ADDENDUM TO THE CONTRACT

Auke Bay Loading Facility Boat Yard Buildings Contract No. DH17-008

ADDENDUM NO.: ONE

DATE ADDENDUM ISSUED: November 23, 2016

SHEET TITLE:
FABRIC BUILDING FOUNDATION PLAN

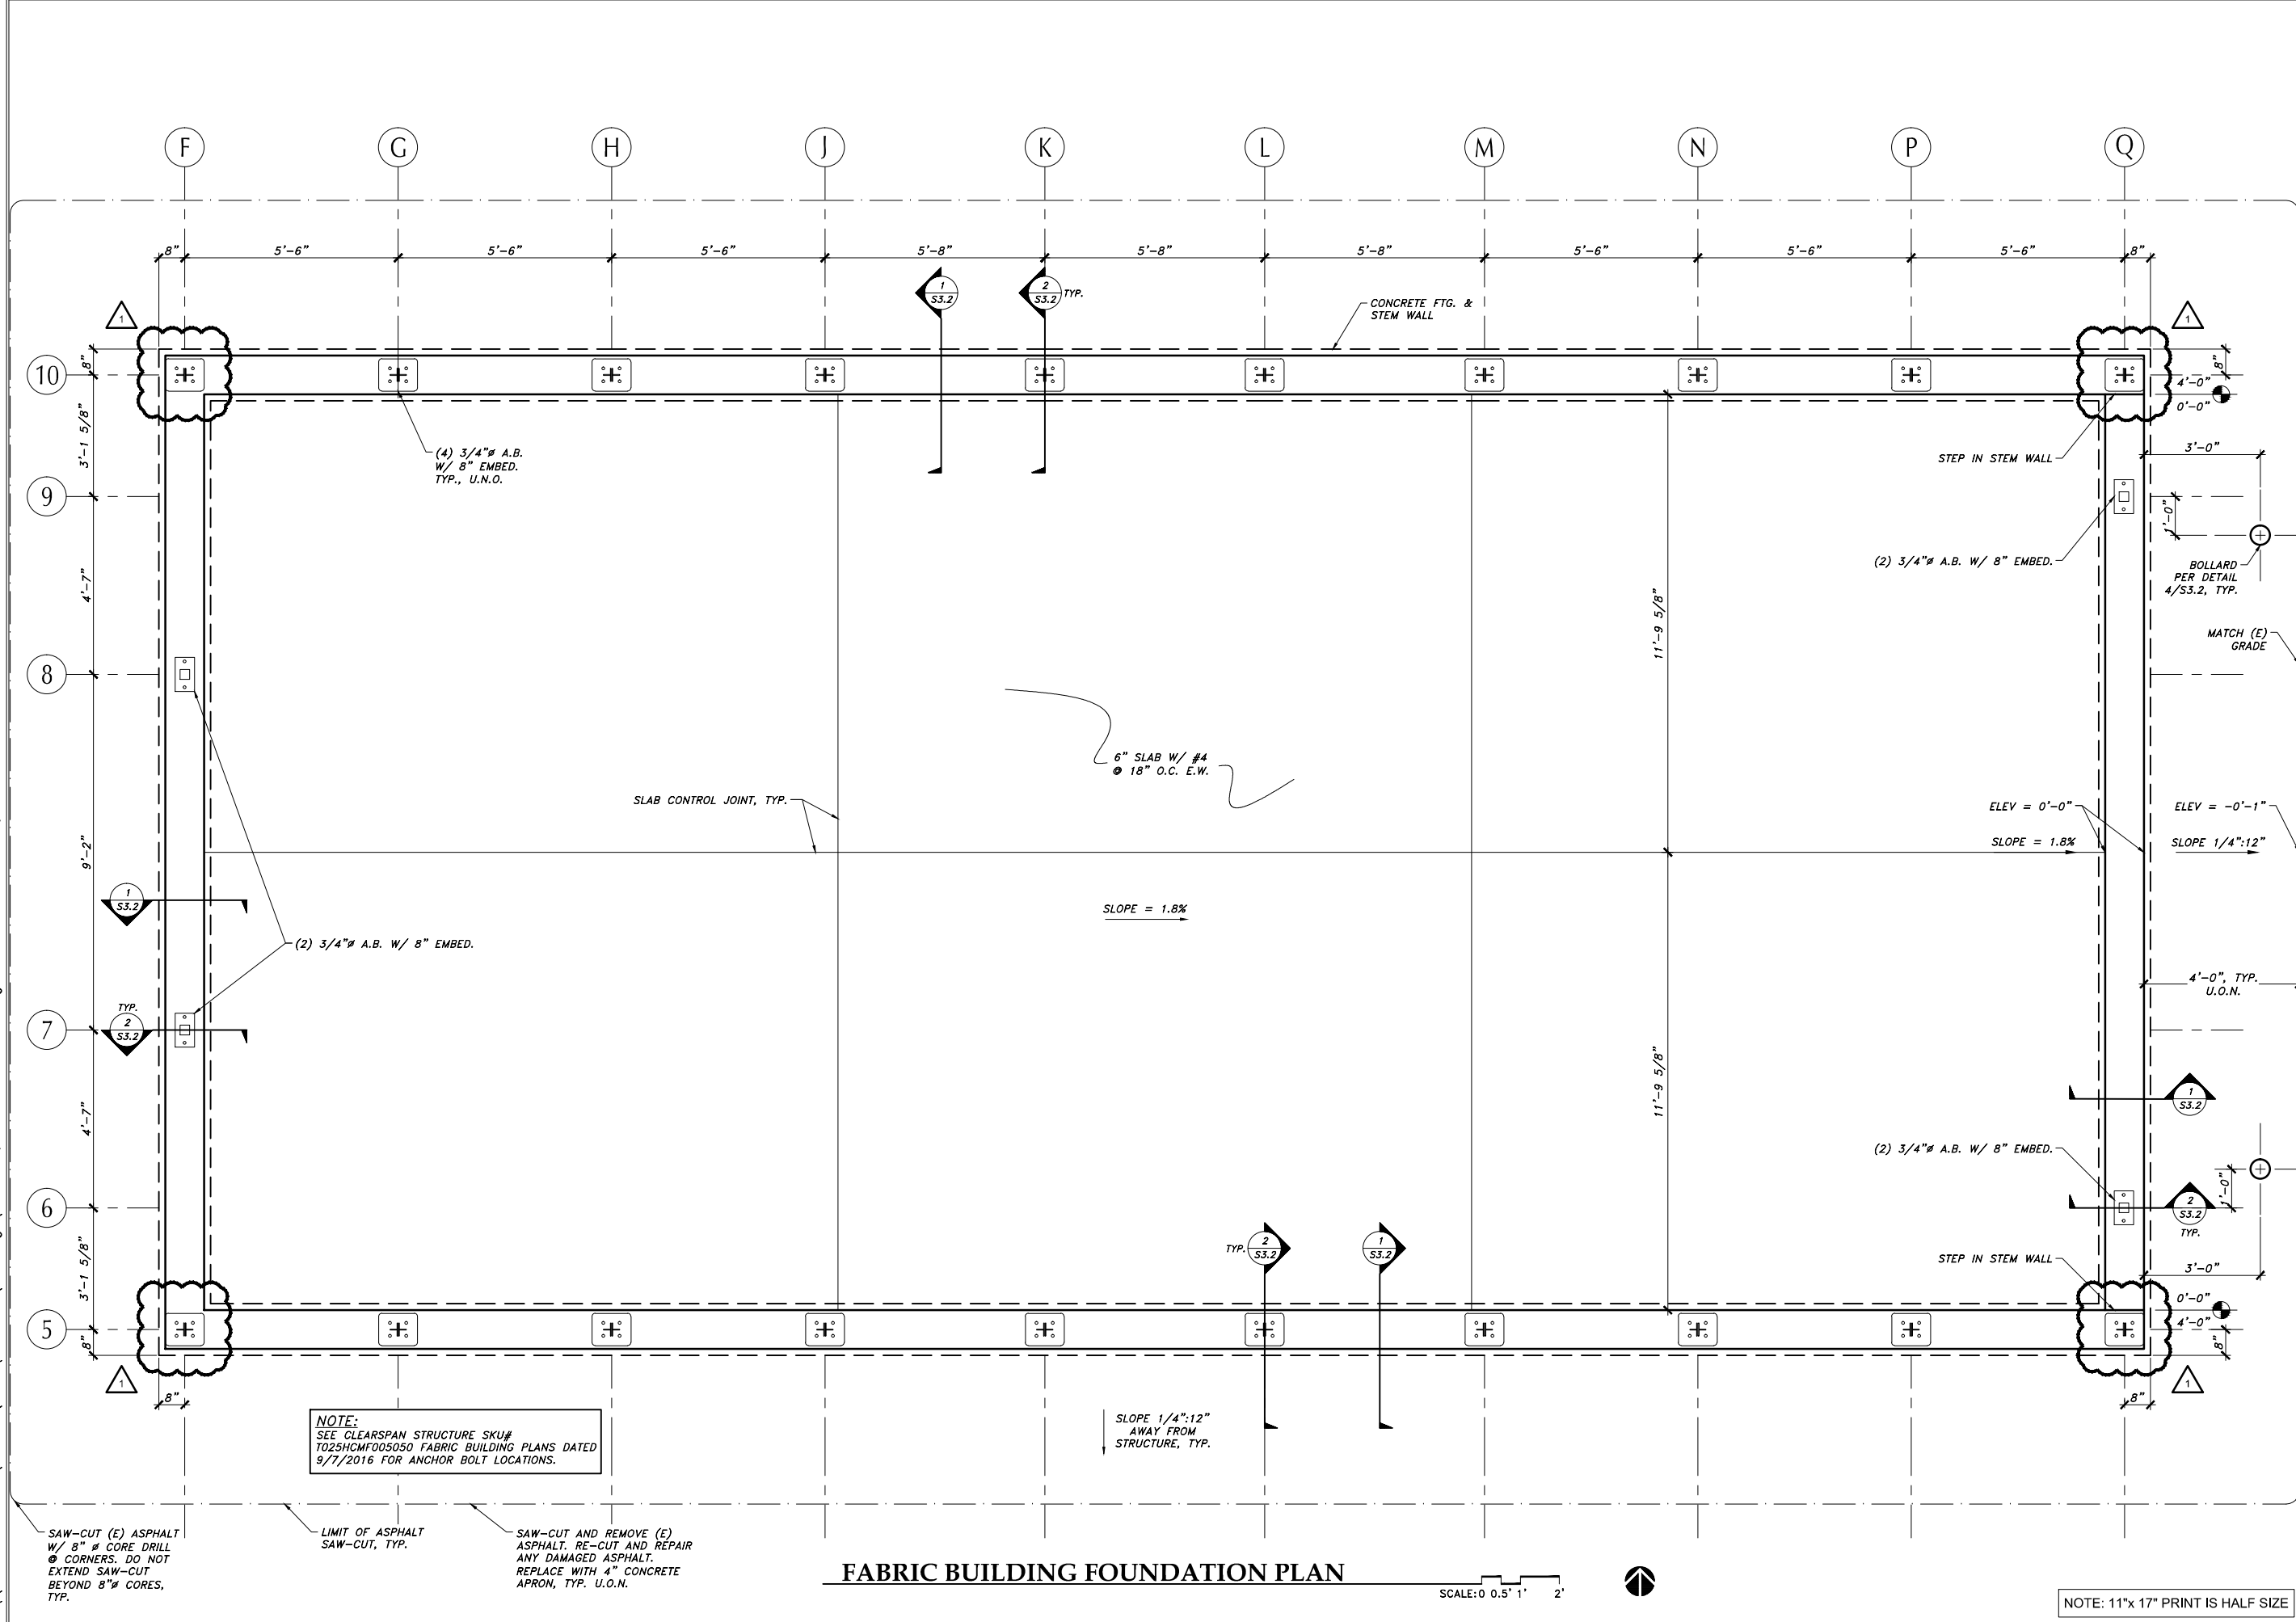
- Item No. 10: SHEET S1.1 - GENERAL NOTES, Foundation, Paragraph 5. **Change** "CONTRACTOR" **to** "OWNER" in the first sentence.
- Item No. 11: SHEET S2.4 – FABRIC BUILDING FOUNDATION PLAN. **Delete** and **replace** with the attached S2.4 – FABRIC BUILDING FOUNDATION PLAN, Revision 1.

No.	Description	Date
1	BASE PLATES & GALV. STEEL	11/23/2016

SHEET TITLE:
FABRIC STRUCTURE FDN. DETAILS

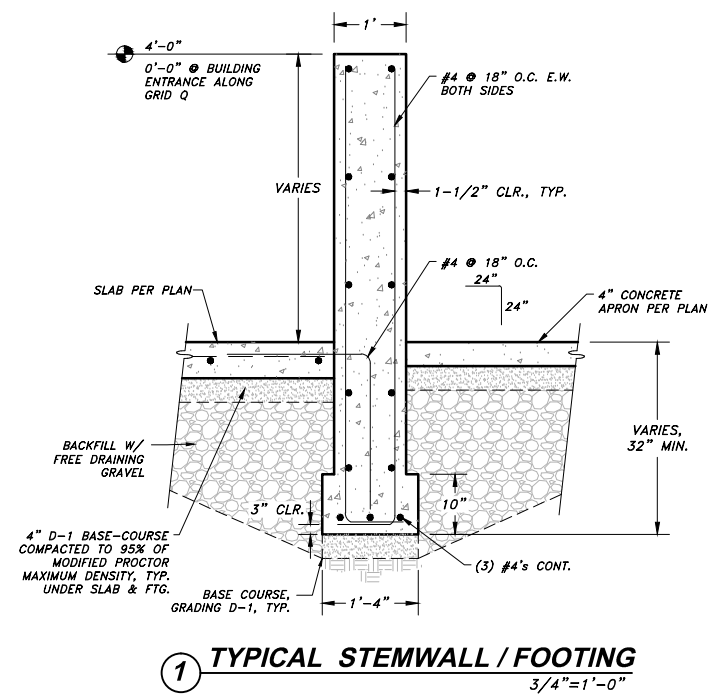
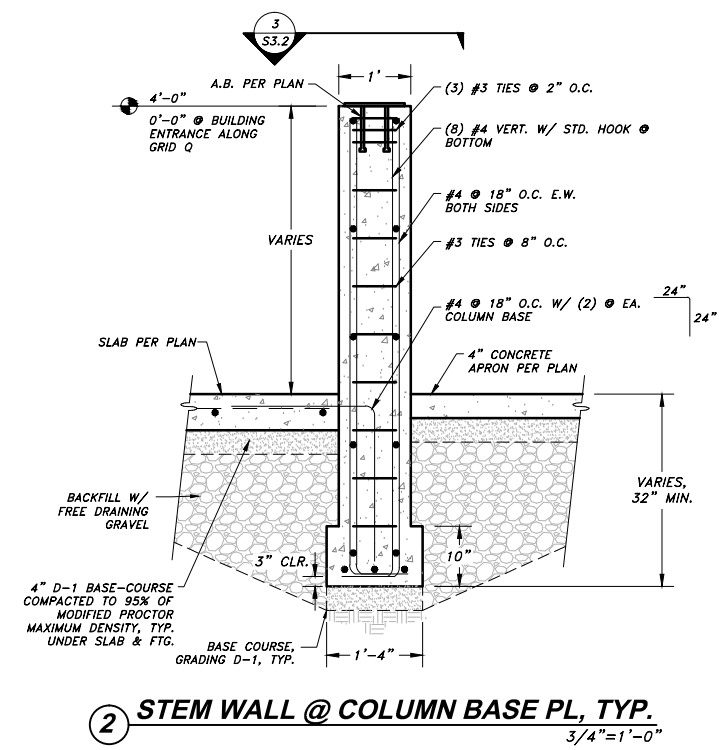
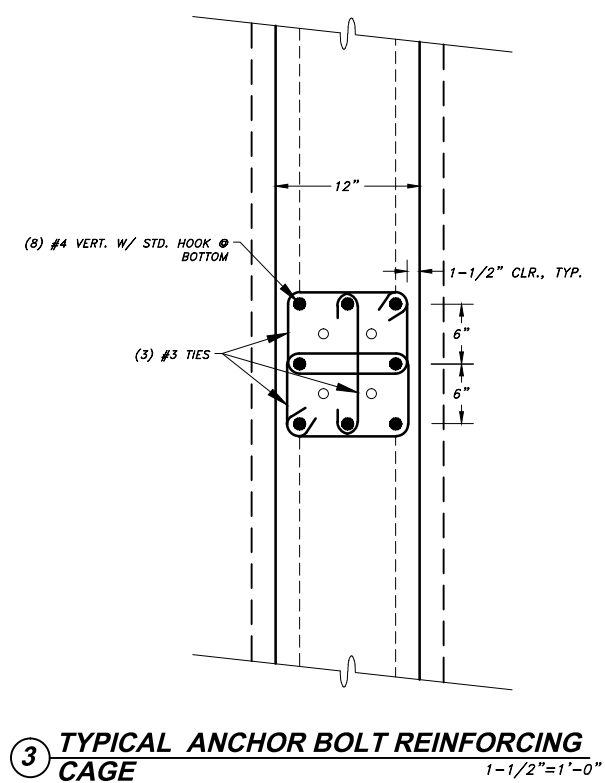
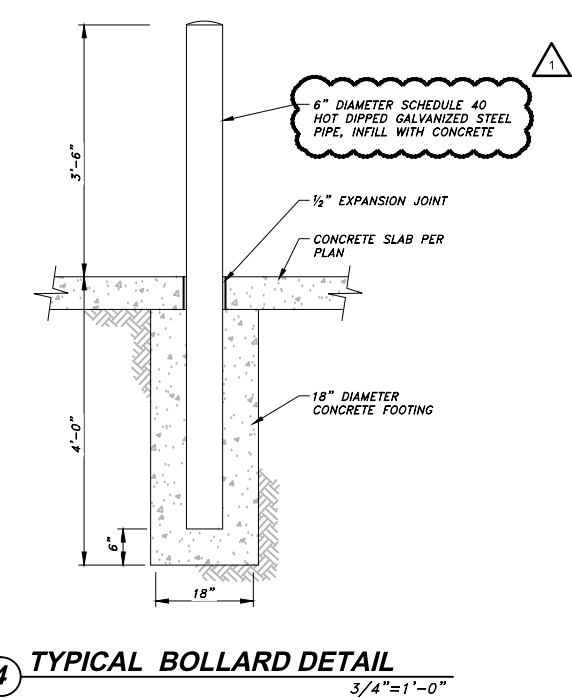
- Item No. 12: SHEET S3.2 – FABRIC STRUCTURE FDN. DETAILS. **Delete** and **replace** with the attached S3.2 – FABRIC STRUCTURE FDN. DETAILS, Revision 1.

No.	Description	Date
△	BASE PLATES & GALV. STEEL	11/23/2016
